September 27, 2019  
File: 121416276

**Reference: Responses to Environment and Climate Change Canada and Nova Scotia Environment Comments on the Receiving Water Study in the Environmental Assessment Registration Document – Northern Pulp Effluent Treatment Facility Project**

**Figure A-1 Simulated Water Levels at the Outfall Location during a Neap Tide on July 10 – 11, 2019**

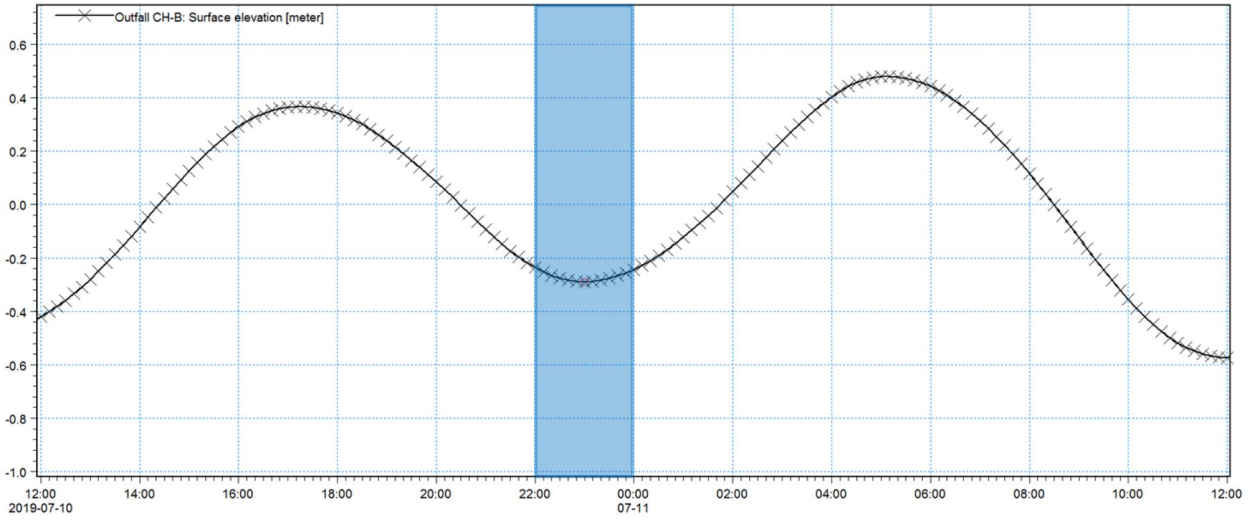
**Figure 2.13 shows the final state of the plume at the end of one month, more than 9 days after the tidal phase depicted by the preceding Figure 2.12. It is not specified whether any of these figures depict the maximum extent of the simulated plume, nor how isolated effluent patches form, nor why the final plume at the end of the month is further south-east than any of the preceding snapshots provided.**

**It would be helpful in understanding the simulation to see how the isolated patches form and disintegrate, as well as an animation of the plume for the few days leading to the final state of the plume in Figure 2.13. The maximum extent of the modelled plume should have been provided, if it is not depicted in one of the figures.**

*Figure A-1 in Appendix A presents the water level variations of a neap tide from July 10 to July 11 at the outfall location, where the slack low tide occurs at 23:00 on July 10. Figures A-2 to A-14 illustrate the spatial distribution of effluent concentration at various stages of the neap tide at 10-minute intervals during the two-hour simulation period of slack low tide from July 10 at 22:00 to July 11 at 00:00. Note that the outfall is located at 526737 m E and 5067239 m N, which is approximately at the center of the plot area (1.4 km x 1.4 km), and that the figure legend for the plume effluent concentration is provided in a lower concentration up to 2.5 mg/L compared to the full scale of 100 mg/L for the effluent discharge concentration at the outfall. The isolated effluent patches are formed by the dynamic changes of current magnitudes, directions and circulation patterns, just like the clouds in the sky driven by winds. We can provide the video clips of the hydrodynamic plume dispersion for better review and observation, if required.*

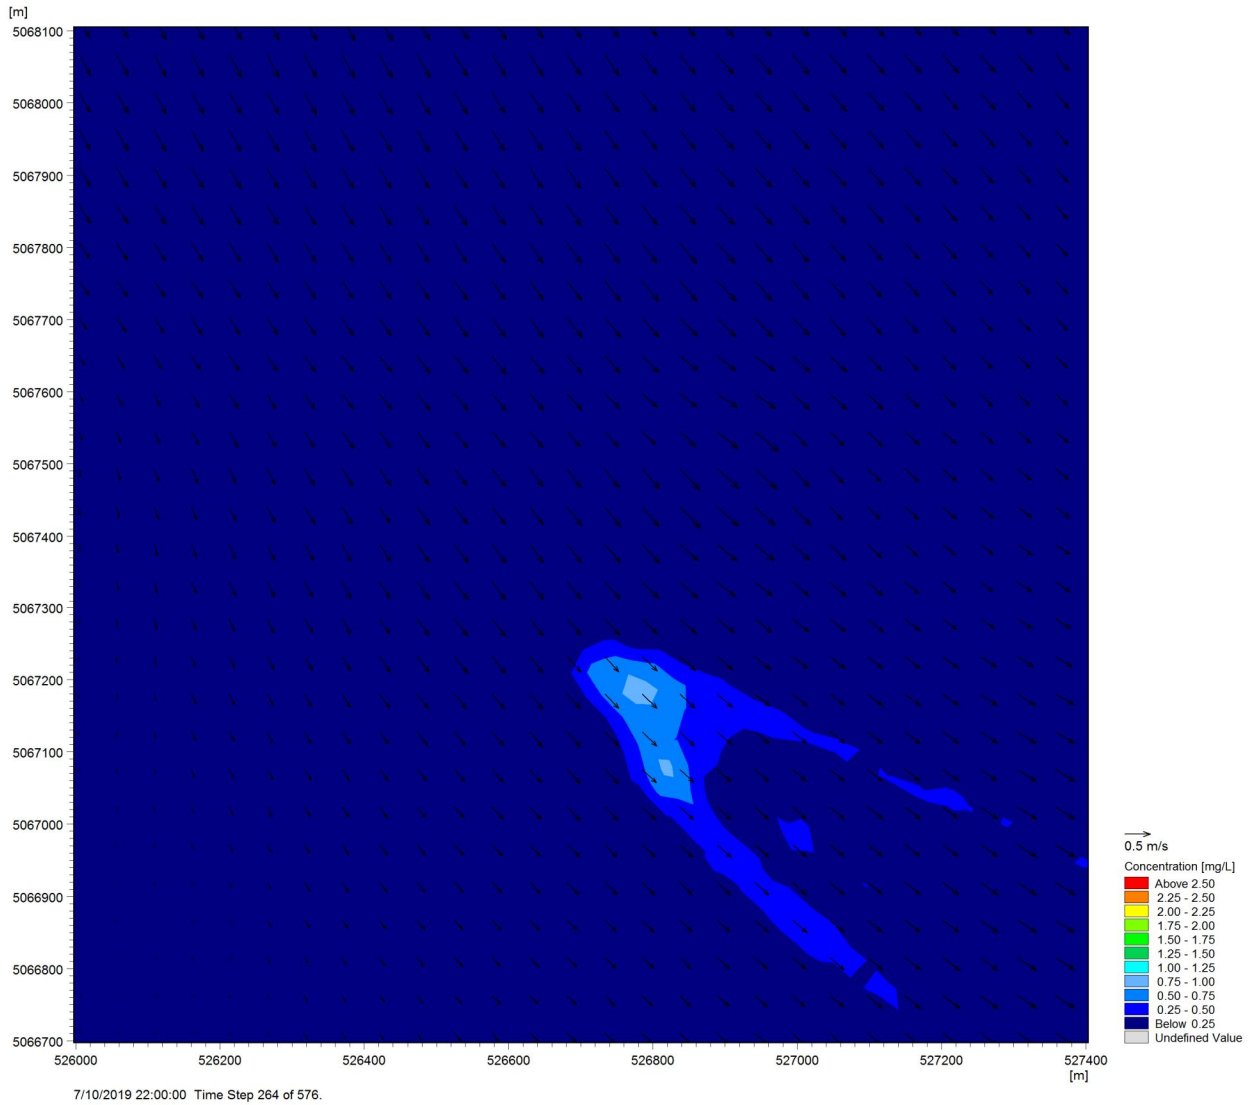
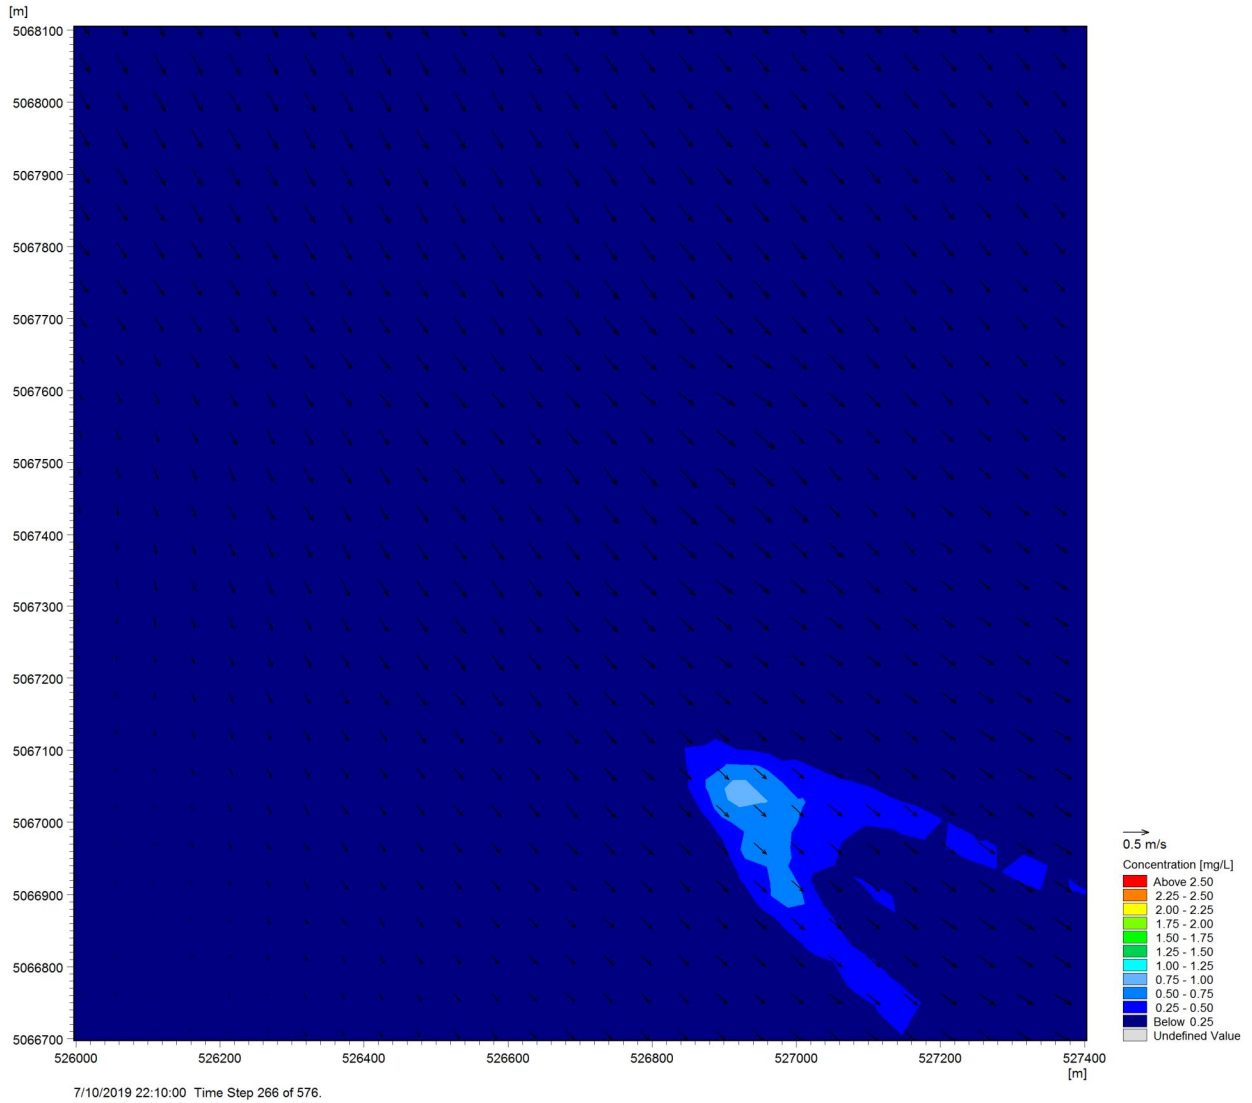
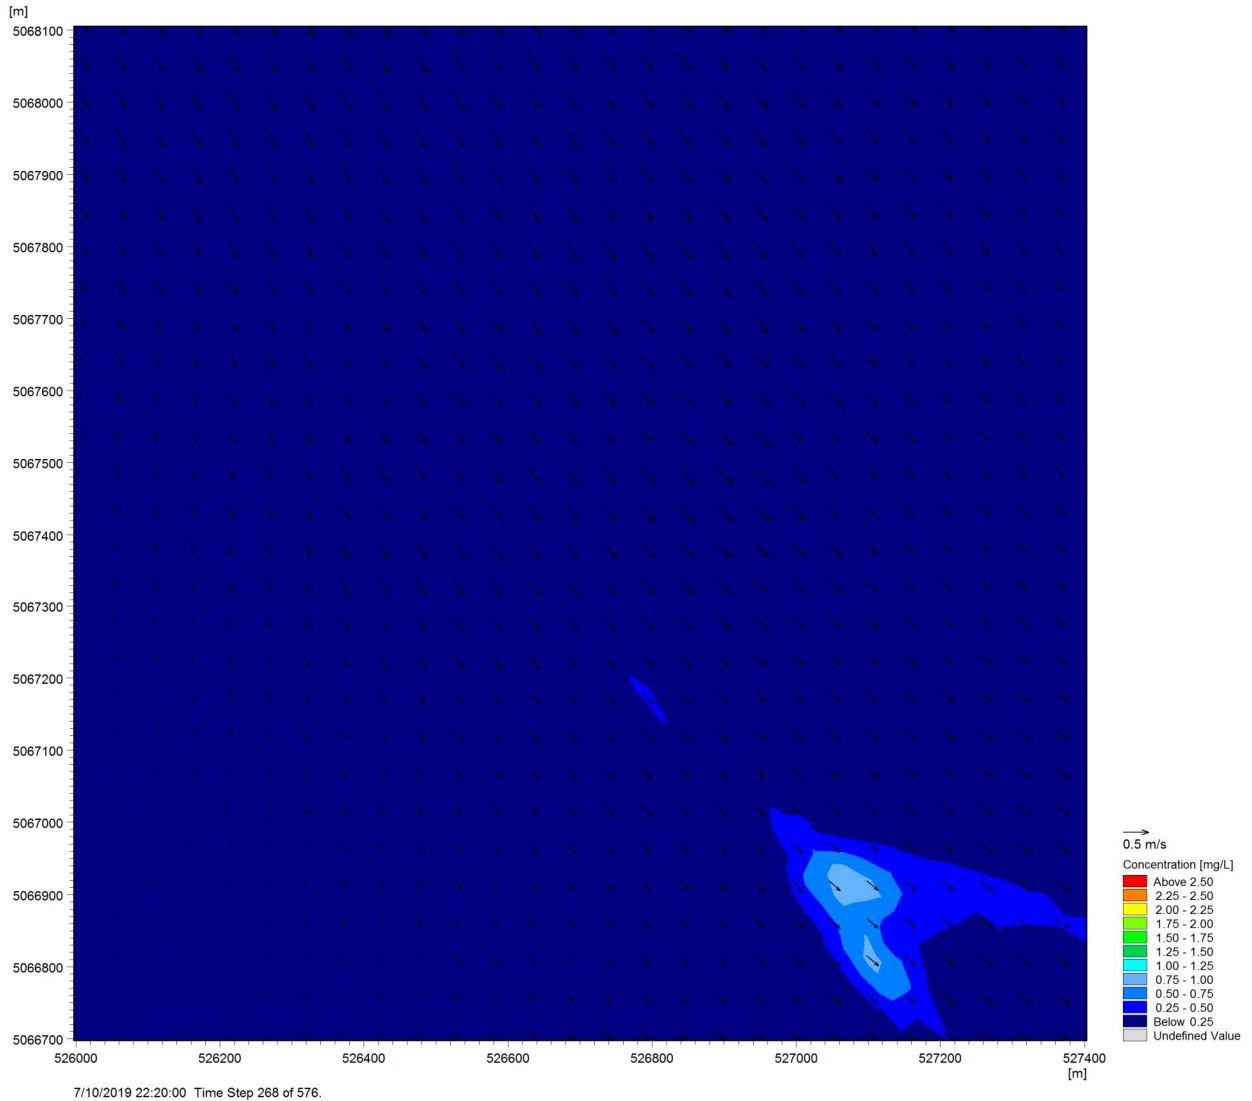
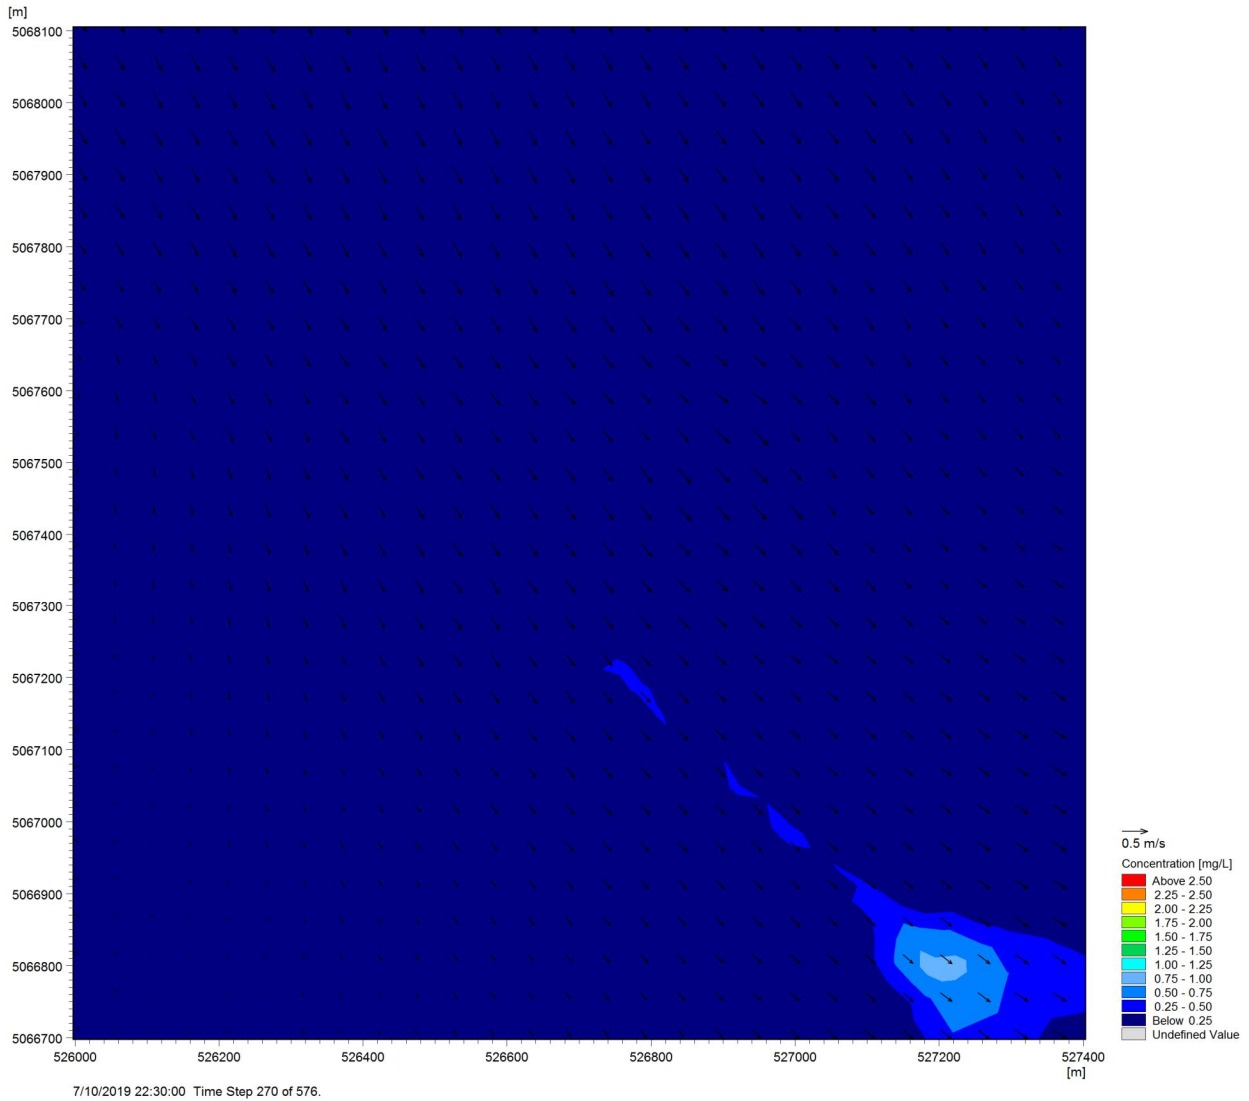
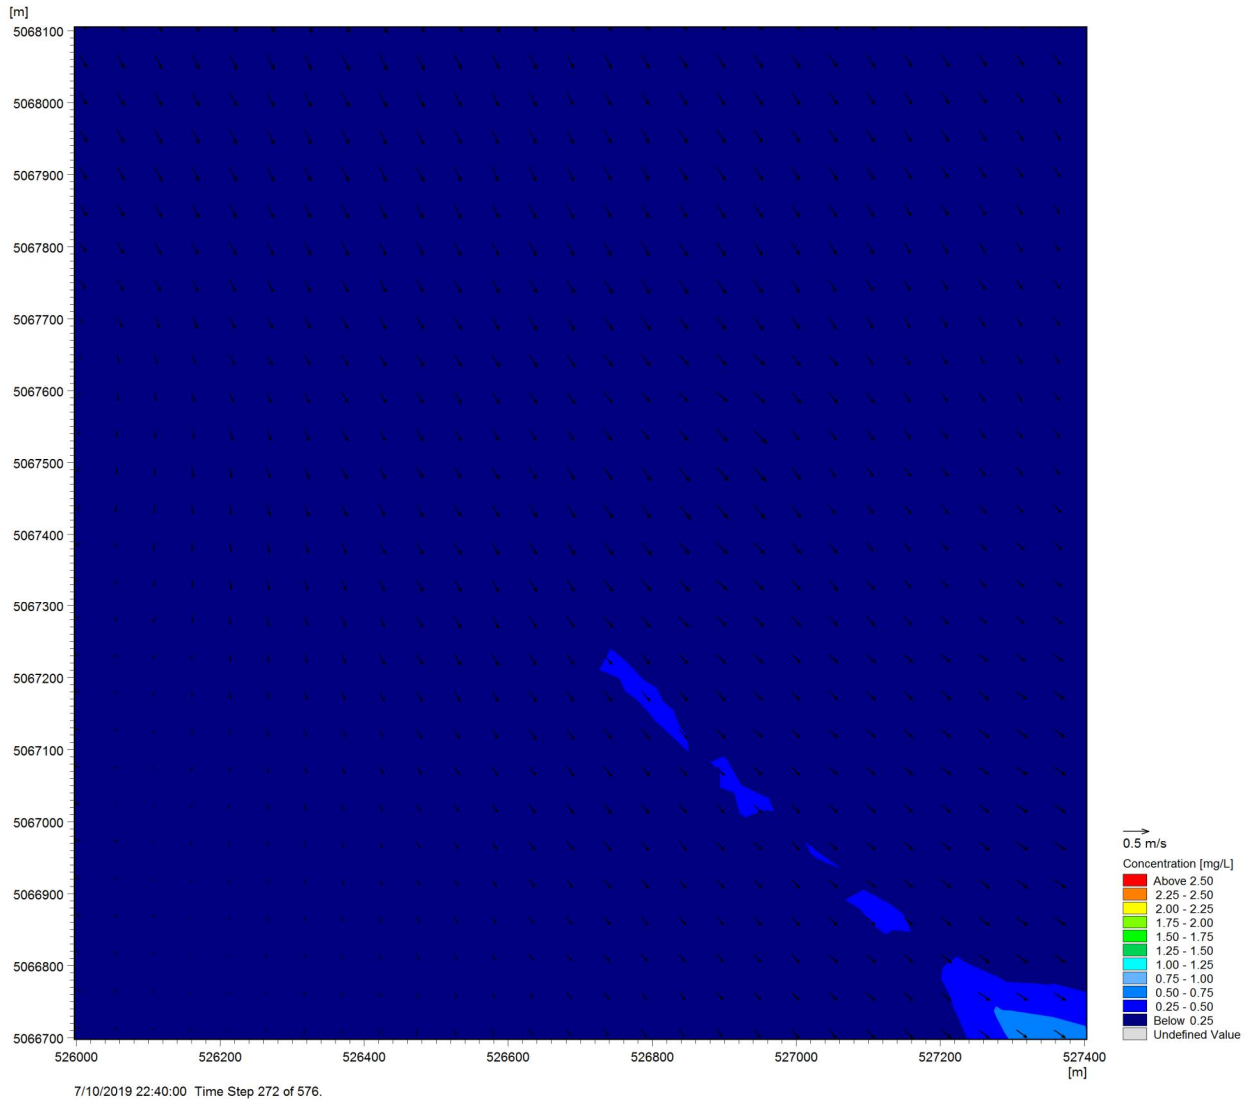
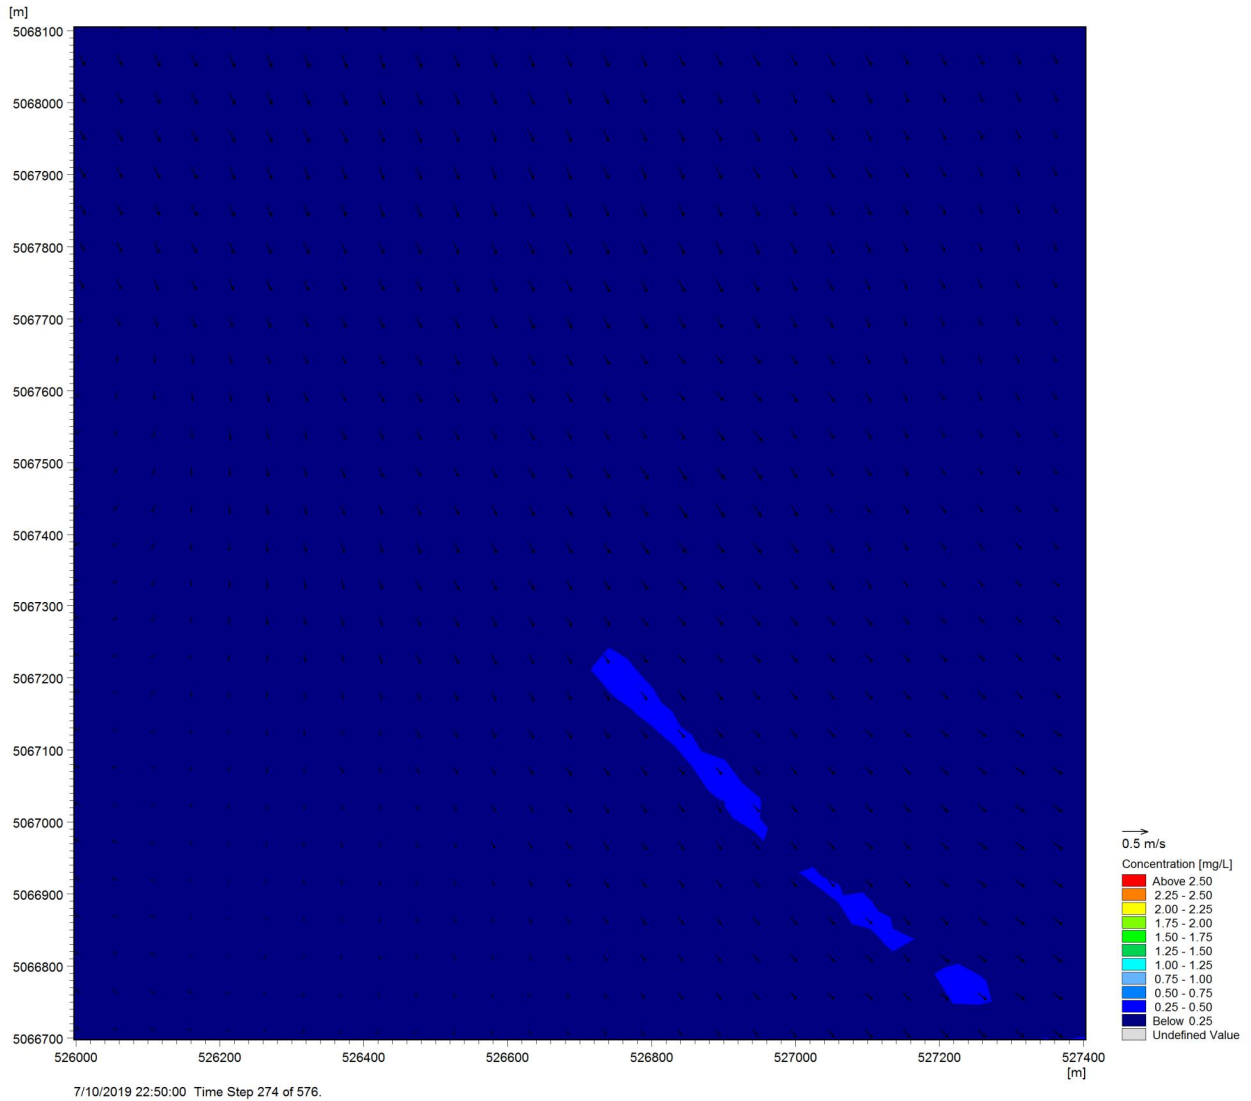
- **Explain if re-entrainment of effluent and sediment at the diffuser location was accounted for in the one-hour period surrounding slack tide. Support this explanation with model results using a smaller time step (30 minutes) if necessary.**

*Please refer to **Responses IR1-14** and **Appendix A** for the presentation of the effluent plume in 10-minute intervals during the two-hour simulation period of a neap tide at slack low tide from July 10 at 22:00 to July 11 at 00:00, which is considered a worse time period over the entire 31 days of simulation time in July and modelled in the updated receiving water study. As it can be observed, no effluent re-entrainment or effluent plume buildup at the outfall location is anticipated.*
